# UNITED STATES PATENT AND TRADEMARK OFFICE

**Office Action Summary**

10/676,924

This is the first Office Action for application number 10/676,924, Door Hook with Hinge, filed on 10/1/03. Claims 1 and 3-33 are pending. Claims 4, 5, 11 and 16-33 are withdrawn.

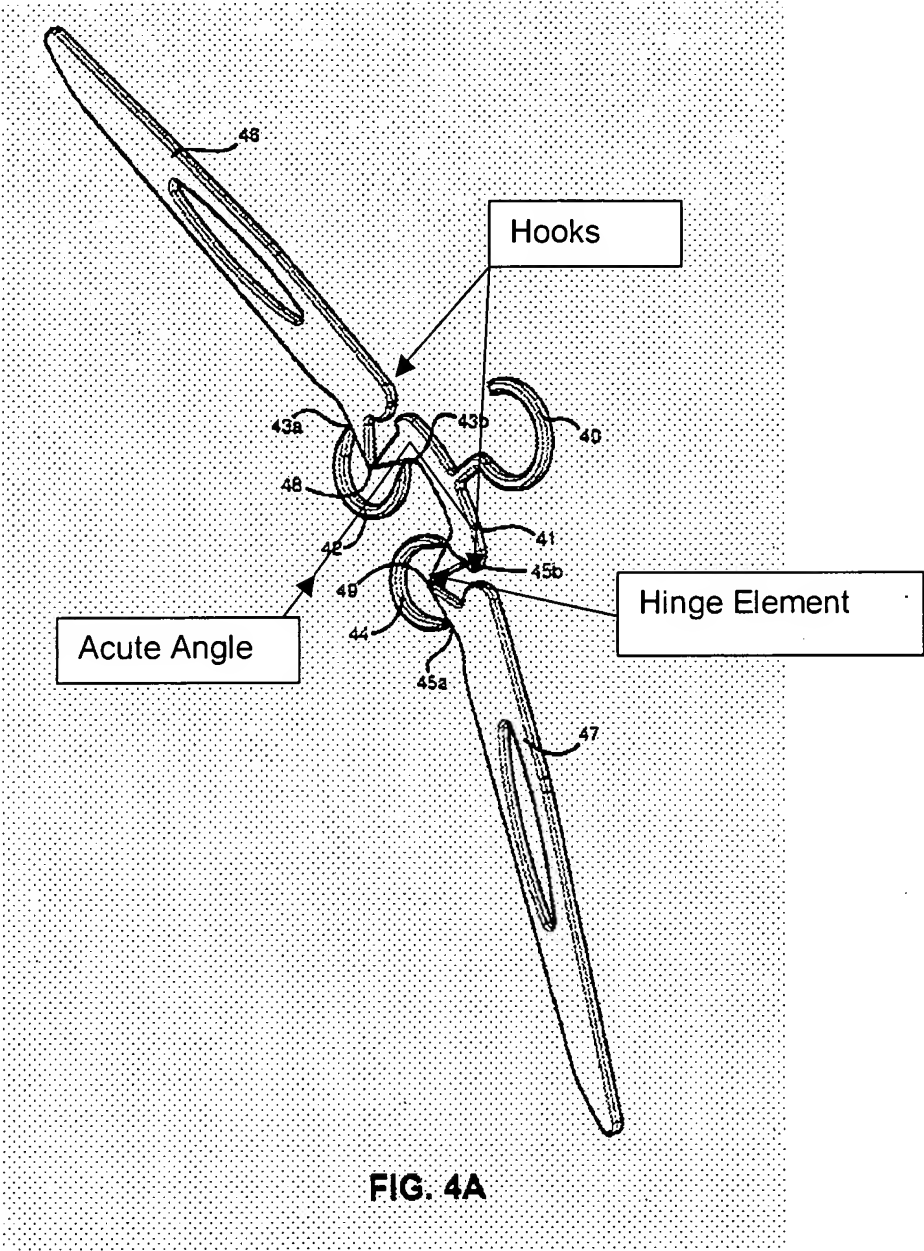
Harvey teaches a plastic hook having a U-shaped bracket having a top member (41) having a front side (See Drawing) having an inside surface, the front side which is attached at an acute angle to one edge of the top member, and a back side (46) having an inside surface, which is attached to an other edge of the top member opposite the one edge, wherein the front and back sides are separated by a first distance, a first hook member (See Drawing) attached to the front side, a spacing member (42) attached to the back side, a second hook member attached to the back side and a living hinge element (48) provided in the back side such that the second hook member is pivotable in a direction toward the front side from a first position in which the back side and the second hook are in a common plane to a second position which, in which the spacing member abuts the inside surface of the back side and faces the inside surface of the front side and the spacing member is 180 degrees apart in the first and second positions, and in the second position the second hook is substantially parallel to the back side and to the common plane of the first position, wherein with the second hook member in the second position the second hook member and the front side and separated by a second distance less than the first distance and a locking member on the back side and a locking member (60).
